State Implementation Plan Review for the Five-Year Regional Haze Progress Report

Prepared by the
Arkansas Department of Environmental Quality
Air Division
Planning Branch

Revised May 2015

Figure 2.1. Percent Contribution of Major Haze Components to 20% Worst Days at Caney Creek Wilderness Area, Arkansas, for the Current Five-Year Average (2007-2011)

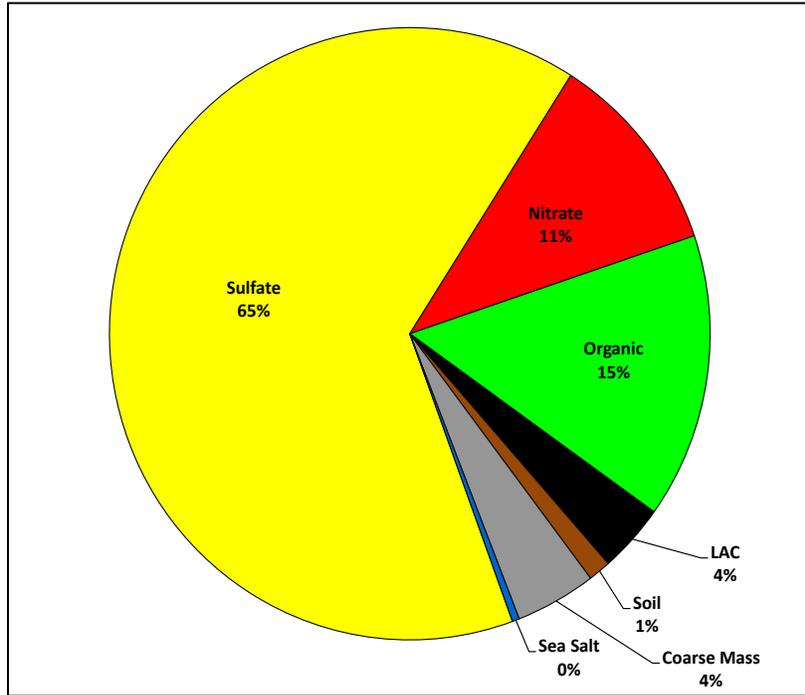
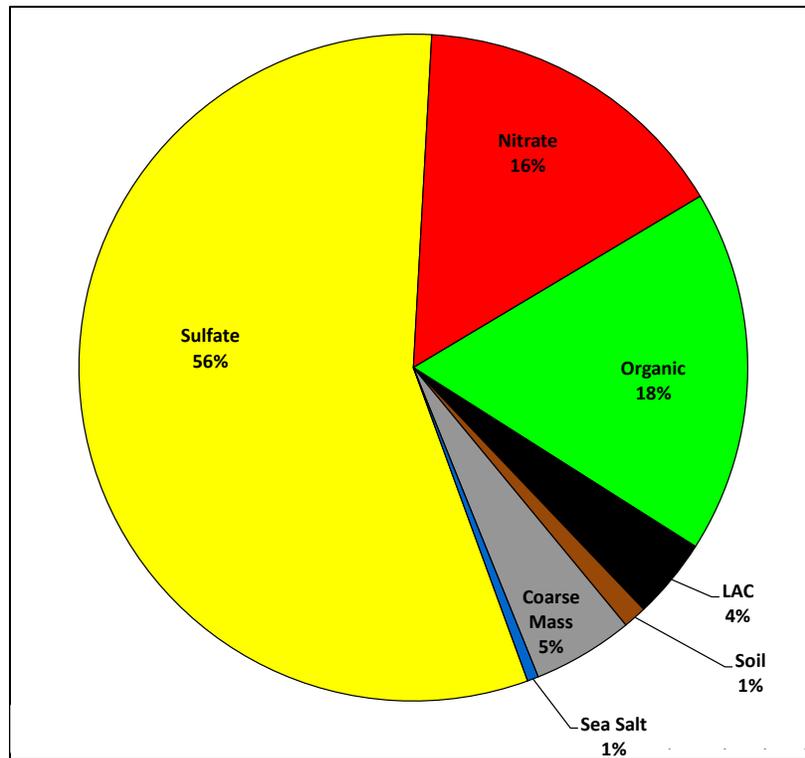
Chapter 2.1: The description of pollutant contributions to haze on the 20% worst days at Caney Creek and Upper Buffalo Wilderness Areas (WAs) is good. Figures 2.1 and 2.2 demonstrate that sulfate is the largest contributor to haze of the 20% worst days. Figure 2.3 demonstrates that Electric Generating Units (EGU) and non-EGU point sources are the largest contributors to sulfur dioxide (SO₂) emissions in Arkansas. Therefore we would expect Arkansas to concentrate on reducing point source SO₂ emissions in the long-term strategy.

Comment 1: In Chapter 2.1, the description of pollutant contributions to haze on the 20% worst days at Caney Creek and Upper Buffalo Wilderness Areas is good. Figures 2.1 and 2.2 demonstrate that sulfate is the largest contributor to haze of the 20% worst days. Figure 2.3 demonstrates that Electric Generating Units (EGU) and non-EGU point sources are the largest contributors to sulfur dioxide (SO₂) emissions in Arkansas. Therefore, NPS would expect Arkansas to concentrate on reducing point source SO₂ emissions in the long-term strategy.
